June 2, 2025

**Re: Portadam® Feasibility Assessment
West Bay Yards Shoreline Restoration
Olympia, Washington
Sage Project No. 033001**

Portadam installed to complete nearshore sediment excavation

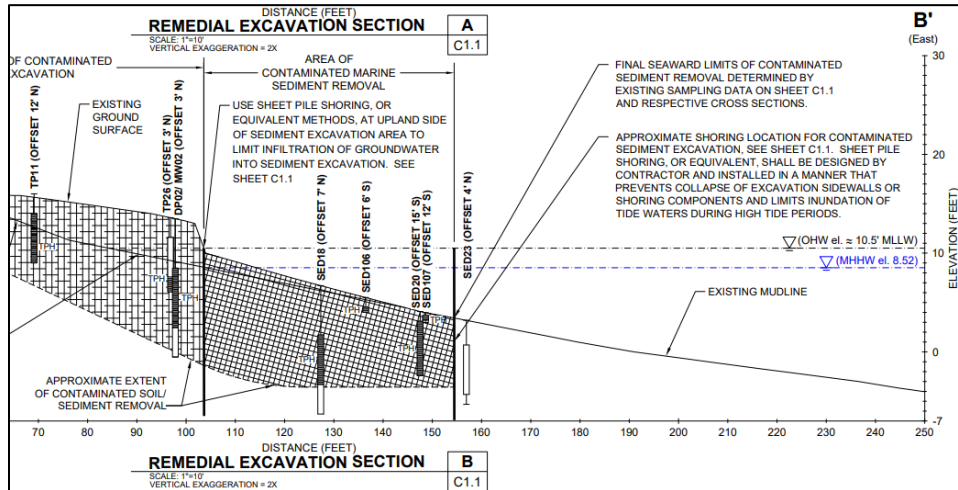
The remediation contractor’s (AEC) original shoring design, as outlined in their July 20, 2012 Excavation and Disposal Plan, for the removal of near-shore sediments called for the installation of sheet pile walls. AEC attempted to install 36 lineal feet of sheet piles on August 29 and August 30, 2012. These attempts were met with refusal; an impenetrable object was apparently encountered at depths of 8 to 10 feet below the mudline. Ecology approved the use of a Portadam shoring system on September 4, 2012. This alternate shoring design is outlined in AEC’s September 5, 2012 Excavation and Disposal Plan (AEC 2012a). The Corps approved the use of a Portadam on September 5, 2012. WDFW had previously approved the use of a Portadam on August 15, 2012.

The Portadam was installed between September 10 and September 20, 2012 and was removed between October 8 and October 15, 2012.

The Portadam described above replaced a contractor-designed sheet pile wall cofferdam. The excerpted plan sheet below shows topographic similarities between the West Bay Yards Shoreline Restoration project and the Irondale Iron and Steel Plant project. Both projects were designed to limit groundwater infiltration into shoreline construction excavations.

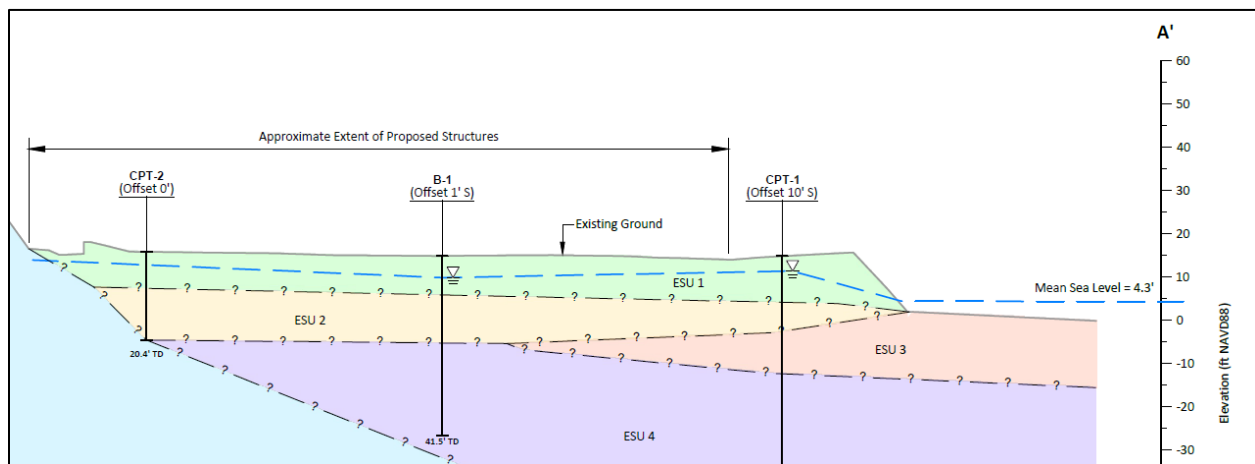
Sage concludes that Portadam construction is not feasible at West Bay Yards due to the presence of soft plastic/cohesive, fine-grained site soils (Engineering Stratigraphic Unit [ESU] 3). The approximate extent of ESU 3 soil is shown below (Landau 2020). The location of ESU 3 soils align with the location of where a Portadam would be constructed.

The estimated shear strength of the ESU 3 soils is as low as 0.2 tons per square foot. Additional loads, such as those contributed by a Portadam, are likely to exceed the bearing capacity of ESU 3 soils. As a result, the Portadam foundation could experience instability and failure. Additionally, excavation and dewatering inside the Portadam present a risk for piping and excavation instability.
